PITANJA I ODGOVORI **QUESTIONS AND ANSWERS**

KONKURS ZA IDEJNO URBANISTIČKO – ARHITEKTONSKO RJEŠENJE STAMBENO – POSLOVNOG KOMPLEKSA U OKVIRU PROJEKTA „GRADSKI STAN“ U PODGORICI

COMPETITION FOR THE CONCEPTUAL URBAN AND ARCHITECTURAL DESIGN OF A RESIDENTIAL AND COMMERCIAL COMPLEX WITHIN THE 'CITY HOUSING' PROJECT IN PODGORICA

Glavni grad Podgorica
Ul. Njegoševa, br. 13, Podgorica
Crna Gora
www.podgorica.me

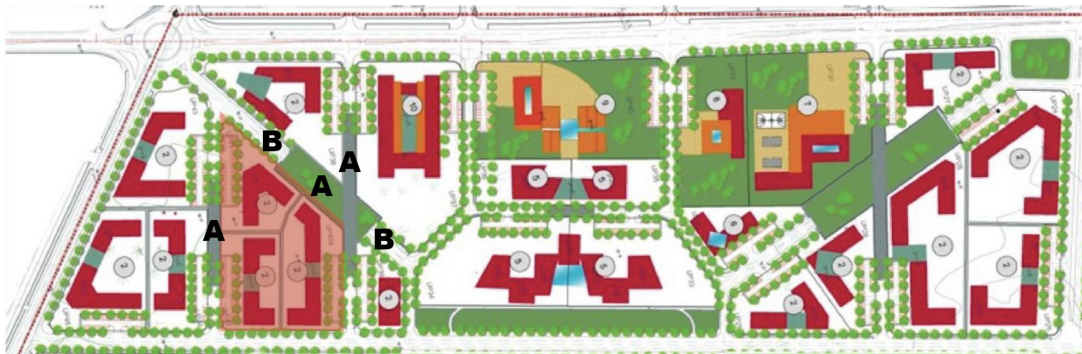
11.2 Could you please clarify what the grey-coloured areas on the site plan represent (marked with the letter A on the attached image)?

11.3 On the provided drawing there is an entrance to an underground garage, i.e. an access ramp from the road (marked with the letter B on the attached image). May we use this entrance as the garage access for our block, or is it necessary to create a new one?

11.3 It refers to a recessed road from which it is possible to plan access to the underground garage.

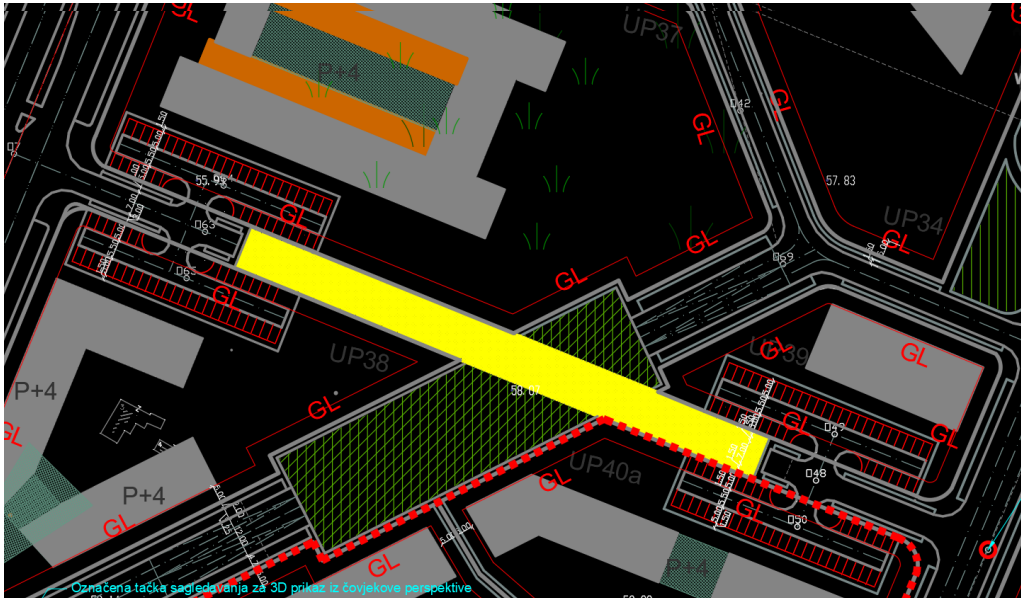
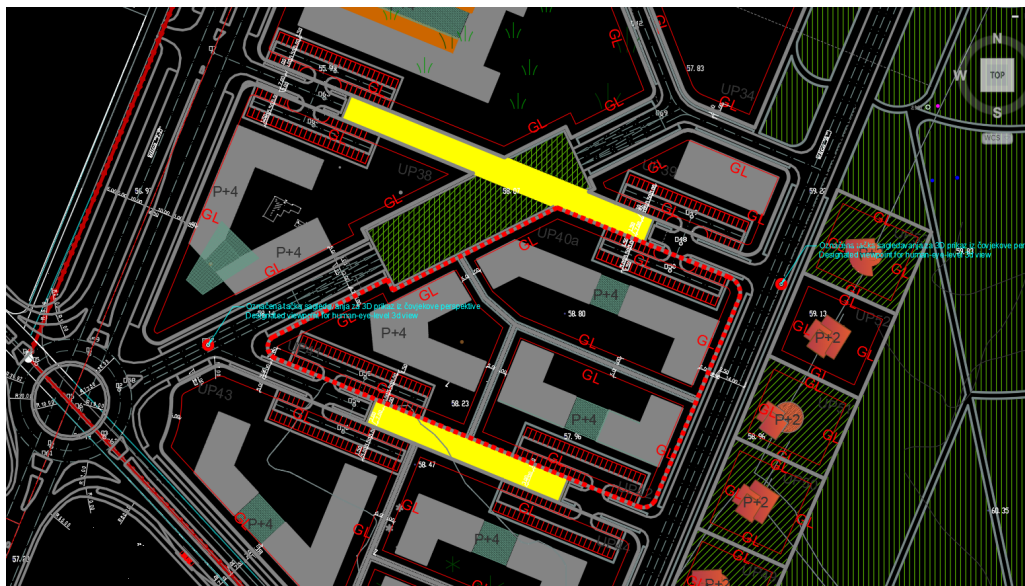
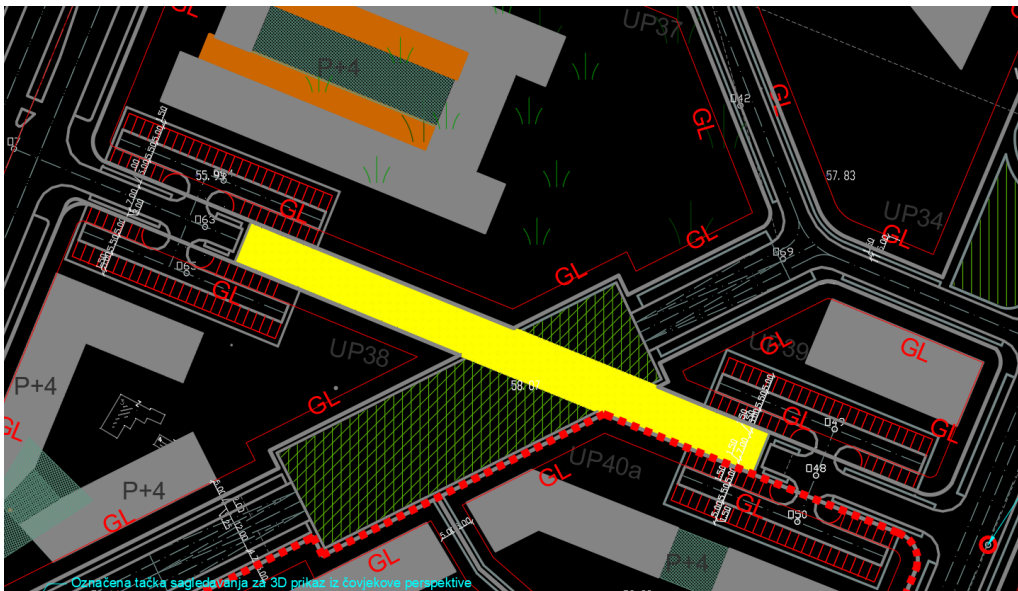
22.3 Please clarify the meaning of the yellow-marked zones on the base map "02-Planned-Regulation-of-the-Site-and-Surroundings".

22.4 How should the relationship between the yellow-marked zone and the visible green surface be interpreted – is it a reserve road or something else?

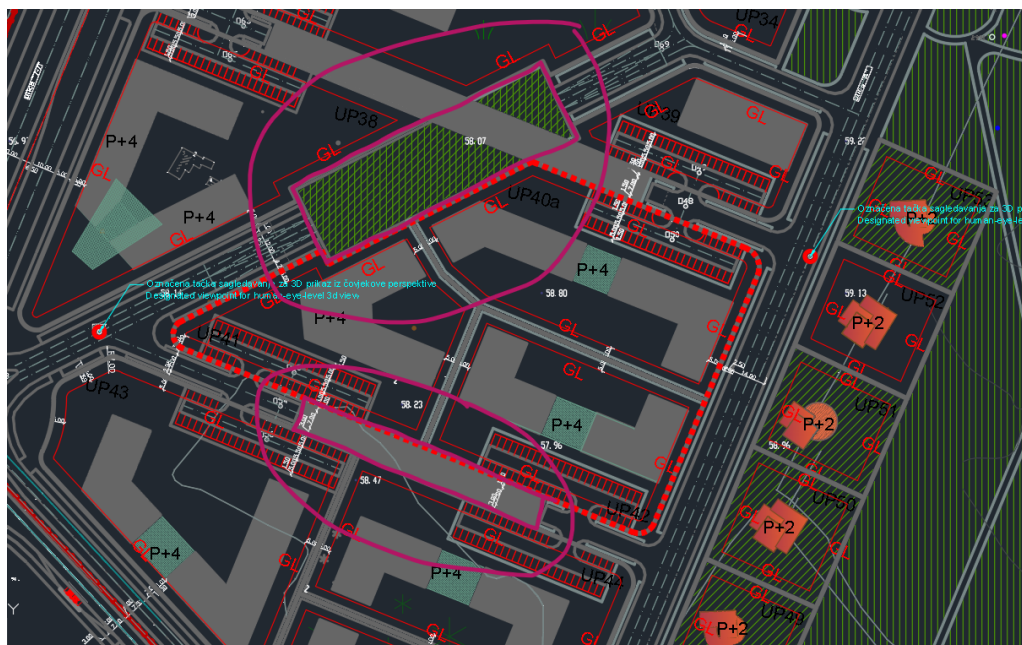
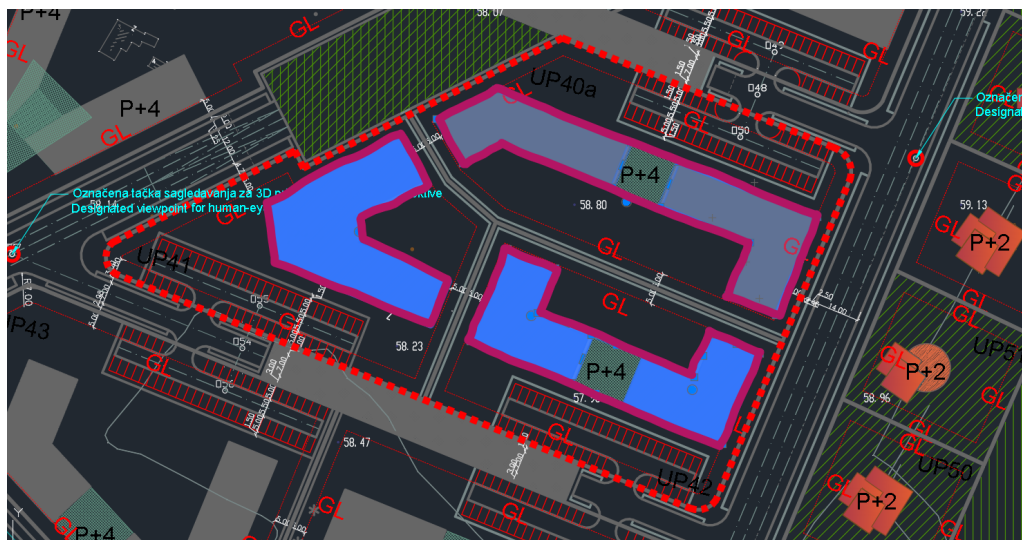
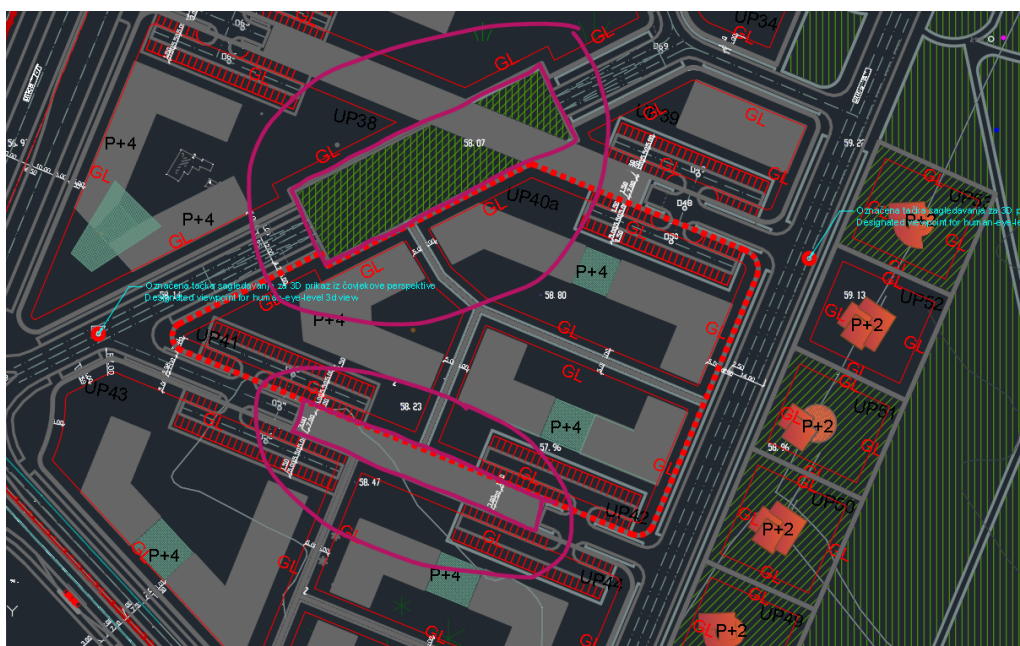
24.2 Is the access to the underground parking already predetermined, or can it be freely designed within the overall solution?

24.3 Are the access roads surrounding the site planned to go underground, and what do the cross-hatches above them represent?

24.2 The plan recommends designing access to underground garages from the recessed road section below ground level (circled in the illustration in the following question), but participants may propose access points in other locations they find suitable.

24.3 The road interrupted by the green hatch is a grade-separated road that passes underground along the hatched section. A green area is planned above it. The roads continuing with grey hatching represent pedestrian streets in those sections.

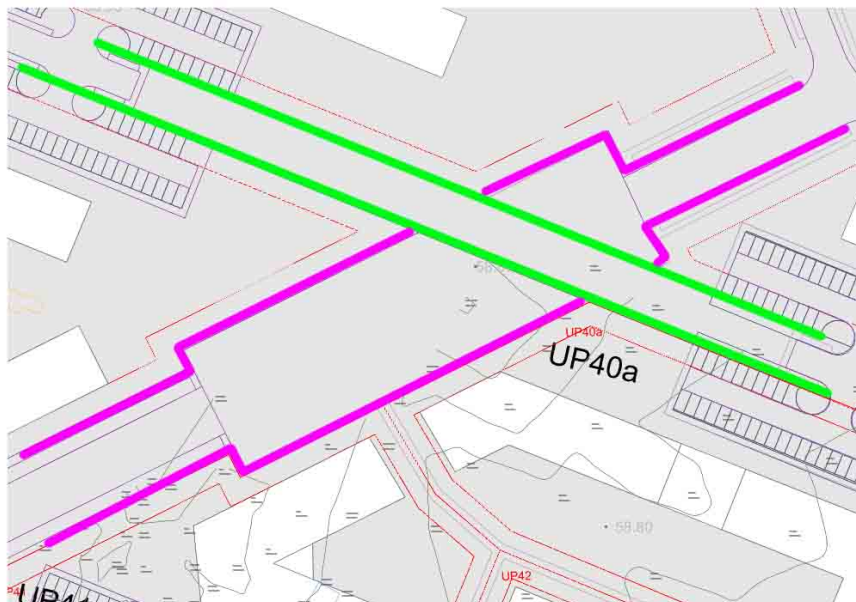
27.2 Are the roads shown in the drawing located at different levels (image below)? And do you perhaps have a site plan that indicates elevation points of the new roads? Also, could you please clarify why the road marked in pink widens in the middle?

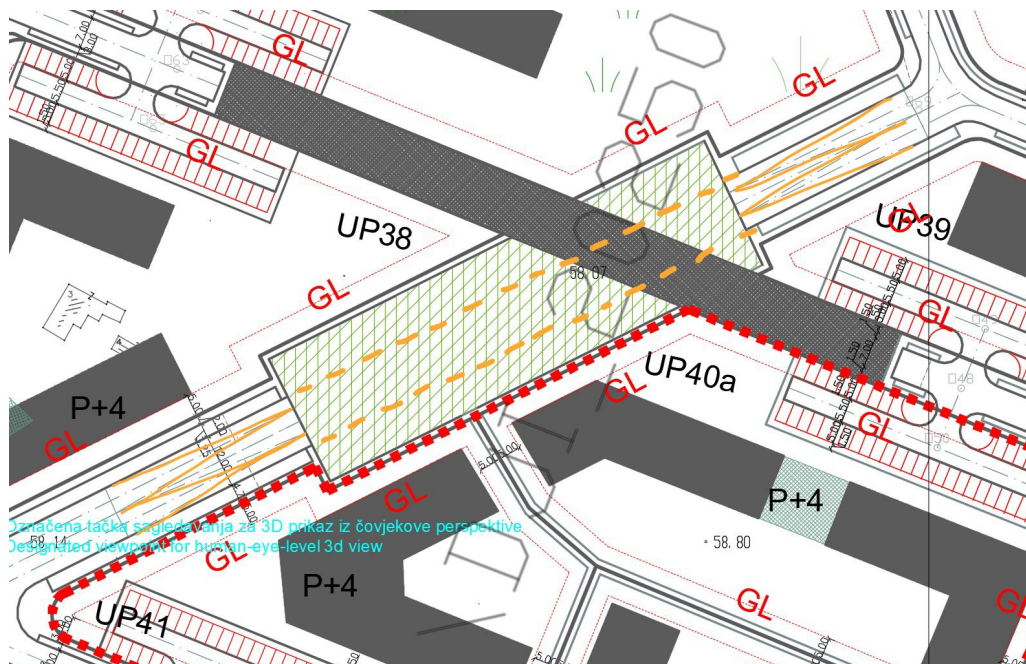
35.1 In the site drawings, the green area layer appears to intersect with the main roadway. Could you please confirm whether the road rises in elevation (so that the green area remains underneath), or if there is another intended spatial or level configuration that we may have misunderstood? (Attachment 1)

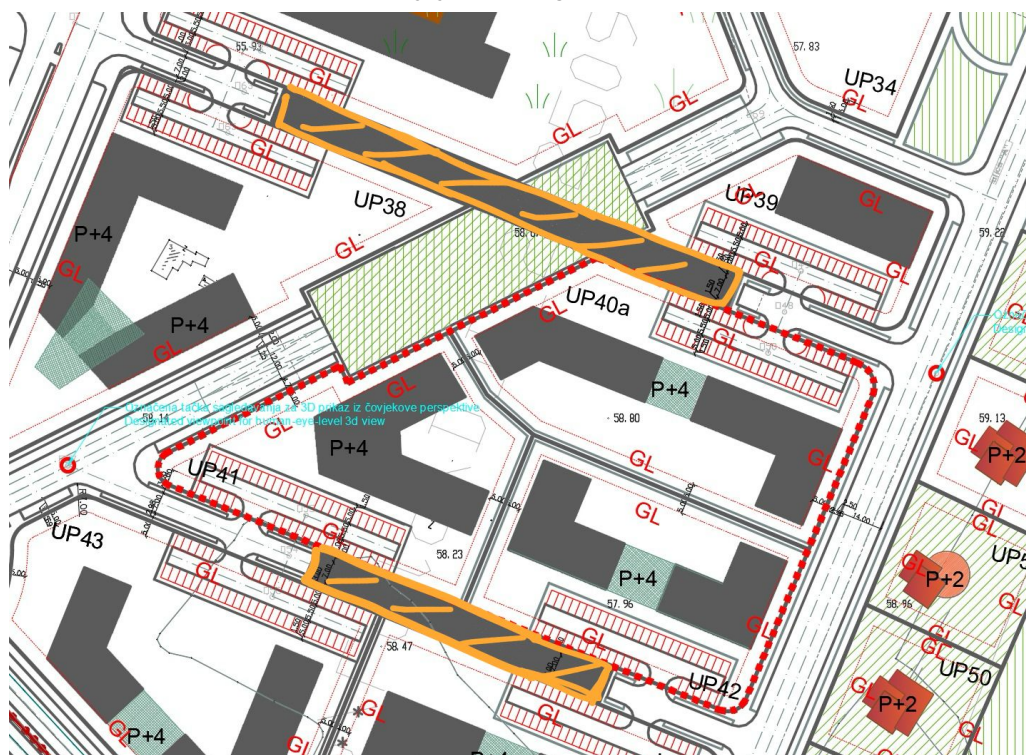
35.2 In the “Kolovoz Plan” layer, there are several hatched areas whose meaning is unclear to us. Could you please specify what these hatched zones represent? (Attachment 2)

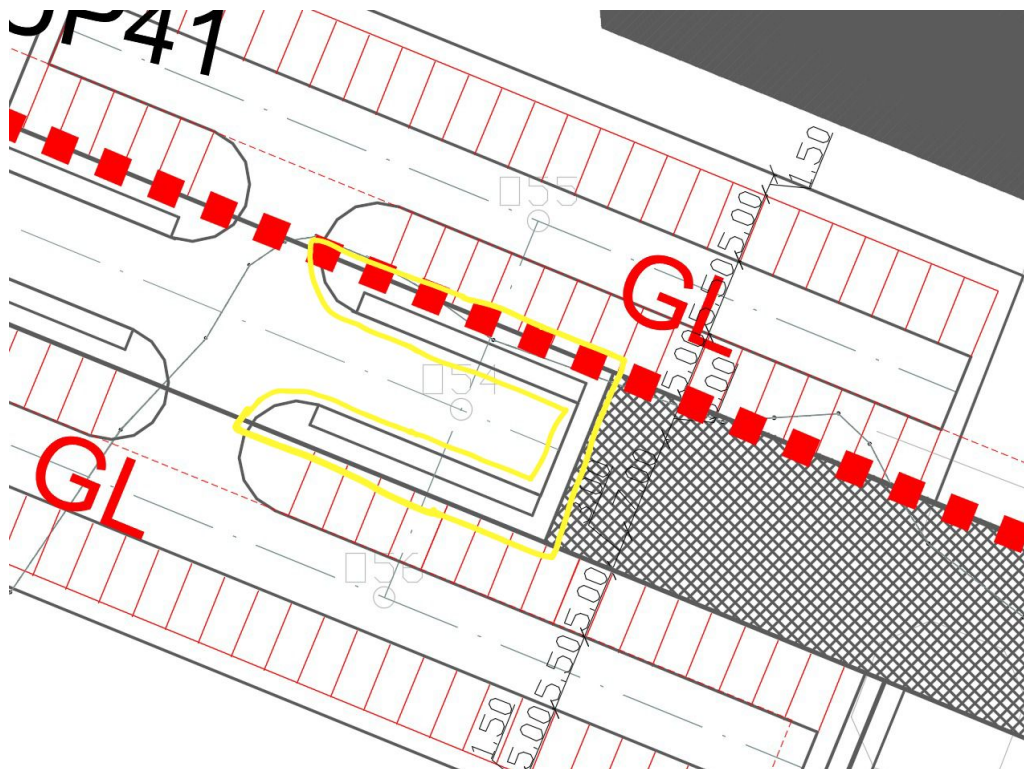
35.3 In the same “Kolovoz Plan,” a road segment approaches from the edge and passes beneath the hatched area. Could you please clarify what the space below this hatched zone represents or what its intended function is? (Attachment 3)
